# **Revision Transmittal**

- TO: Cessna Distributors and Authorized Service Facilities and CPC's
- SUBJECT: Multi-engine Service Bulletin MEB07-1 Revision 5, Pilot and Copilot Secondary Seat Stop Installation.

MEB07-1 Revision 5

PILOT AND COPILOT SECONDARY SEAT STOP INSTALLATION

Figure 1. Identification of Secondary Seat Stop Installation Configurations (Sheet 1)

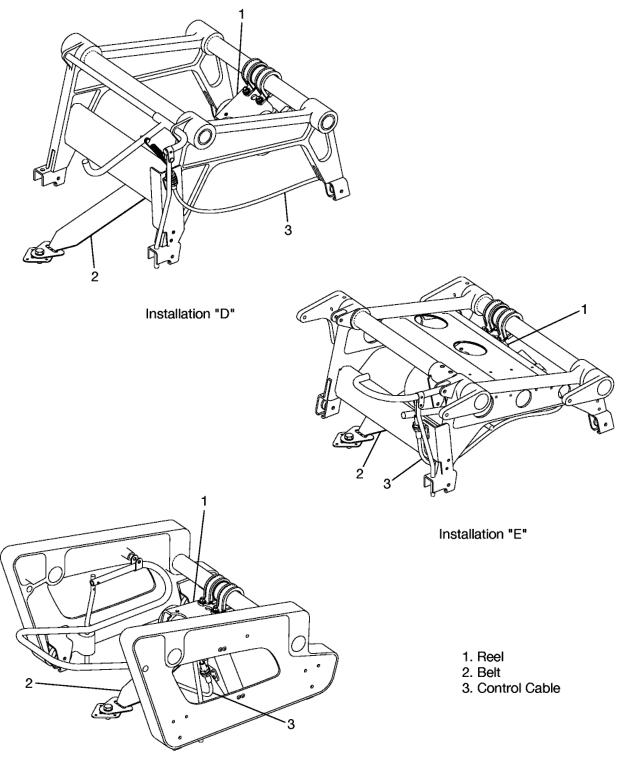
For your convenience the typical installation of the secondary seat stop installation configurations are shown in Figure 1.
